**Committee of Experts on the Transport of Dangerous Goods
and on the Globally Harmonized System of Classification
and Labelling of Chemicals**

**Clarification of the classification of ammonium nitrate based
fertilizers – draft amendments to the Model Regulations and
the Manual of Tests and Criteria**

**Annex 3 of document ST/SG/AC.10/C.3/2016/29
(correspondence between the proposed flow chart and the
existing criteria for UN 2067 and UN 2071)**

Transmitted by the expert from Sweden

Rows 4-10 in the flow chart correspond to SP307(a).

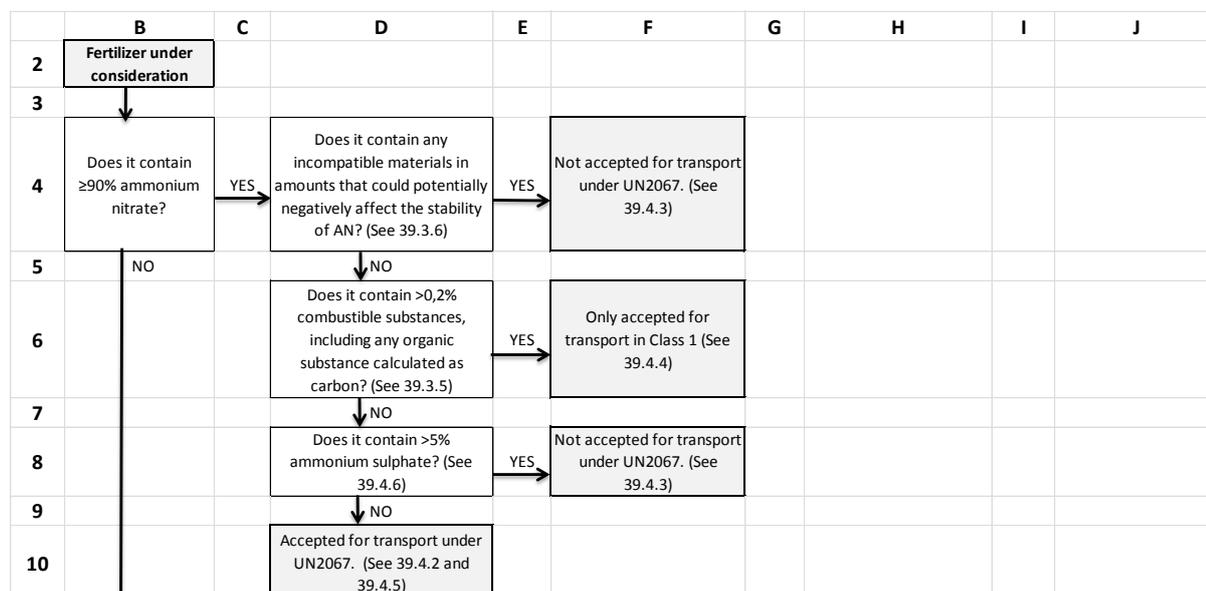
Condition α_1 is contained in Box B4 and condition α_2 is contained in Box D6. Condition α_3 is superfluous since condition α_2 already restricts the amount of organic material in the fertilizer, and hence there is no need for a corresponding box in the flow chart to cover condition α_3 .

Condition α_4 is contained in Box D4, but the wording has been altered. The reason for this is that the current condition is not very clear and also has a zero-tolerance towards material that is not inert, which is unrealistic considering e.g. naturally occurring contaminants. Box D4 set a tolerable limit to incompatible materials in that they are allowed as long as they cannot potentially negatively affect the stability of AN. In paragraph 39.3.6, to which Box D4 refers, it is exemplified what is meant by “incompatible materials”, and it is specified that such materials should not be added deliberately.

Box D8 contains what appears to be a new condition on the content of ammonium sulphate (AS). However, this condition is in fact already contained in SP307 since “nitrogen type” AN-based fertilizers that contain AS as a nutrient should adhere to the conditions of SP307(c), which is especially targeted at binary AN/AS-fertilizers and sets a limit of maximally 70% AN in such mixtures due to the effect of AS to enhance the explosive power of AN¹ (see also section γ below). What Box D8 does is not to create a new condition but rather to open up for a small addition of AS for quality reasons – something that is frequently done for fertilizers in practice but where it is not clear whether that is actually allowed within SP307 or not. The flow chart clarifies that it is allowed to add AS for quality reasons, by setting a limit of 5%.

The answer “YES” to the questions in Box D4 or D8 directs to the fertilizer being “Not accepted for transport under UN2067”. However, it may be transported under another suitable UN-number based on conditions as explained in paragraph 39.4.3 to which Box F4 and Box F8 refers. An answer “YES” to the question in Box D6 leads to “Only accepted for transport in Class 1”, because mixtures of ≥90% AN and combustibles are known to have explosive properties. Hence they should not be transported as anything else than under a suitable UN-number in Class 1, which is further emphasised in paragraph 39.4.4 to which Box F6 refers.

Rows 4-10 in the flow chart thus correspond to SP307(a). The flow chart clarifies that a small addition of AS is allowed for quality improvement, and that mixtures of $\geq 90\%$ AN and $>0,2\%$ combustibles shall be transported in Class 1.

Rows 42-46 in the flow chart correspond to SP307(c).

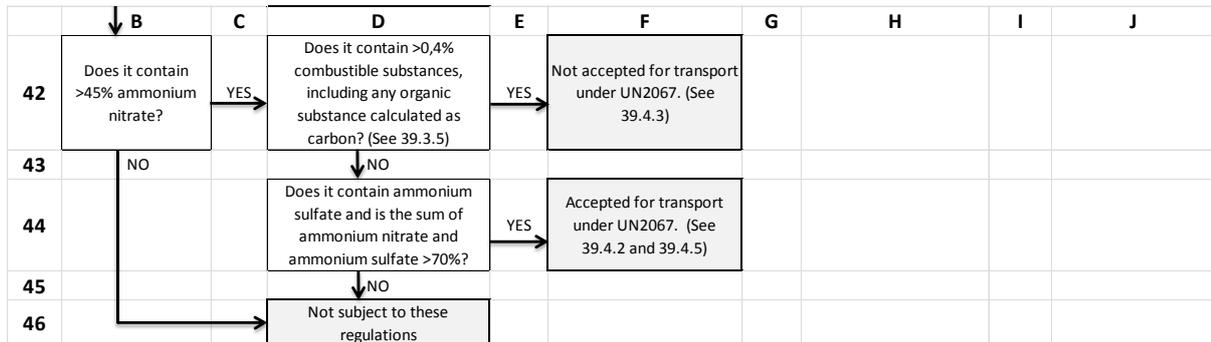
Condition γ1 is already covered, since fertilizers that are not of the “nitrogen type” are compound fertilizers that are already directed away by Box B12. Condition γ3 is contained in Box B34, where fertilizers with >70% AN are directed away. Condition γ2 is contained in Box B42, condition γ4 in Box D42 and condition γ5 in Box D44.

Rows 18-22 in the flow chart correspond to SP 193 and paragraph 38.2.3.3.

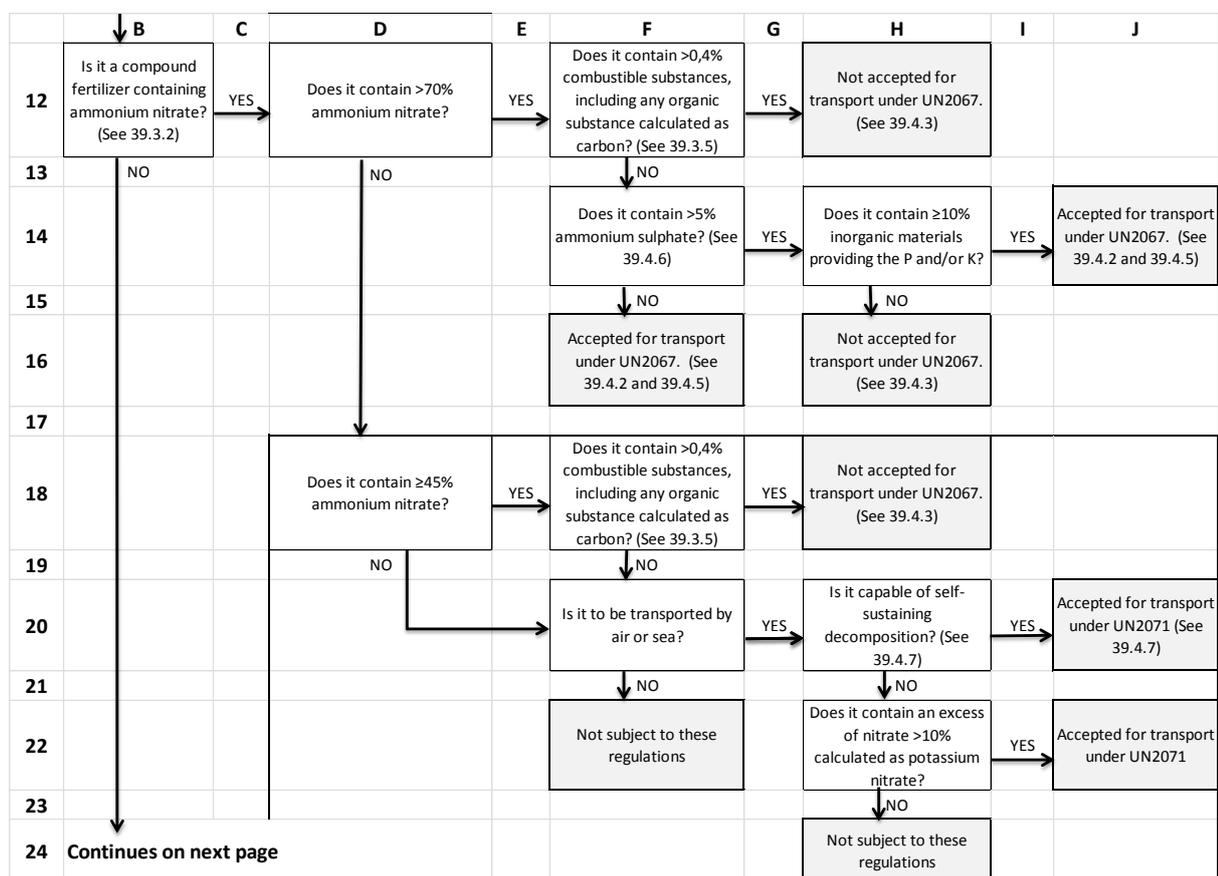
Condition δ1 is contained by the fact that this, through Box B12, only applies to compound fertilizers. Condition δ2 is in Box D12. By Box D18 and F18 condition δ3 on the amount of combustibles is implemented only for fertilizers with $>45\%$ AN. Condition δ4 is in Box F20, and the condition δ5, which is actually two conditions (“either ... or ...”), is implemented through Boxes H20 and H22.

An answer “YES” to either Box H20 or H22 directs to “Accepted for transport under UN2071”, while if the answer is “NO” to both of these boxes the fertilizer is “Not subject to these regulations”, which is in accordance with SP193 and paragraph 38.2.3.3 of the UN Manual, respectively. If the fertilizer is not to be transported by air or sea, the answer “NO” to Box F20 also directs to “Not subject to these regulations”, in line with SP193.
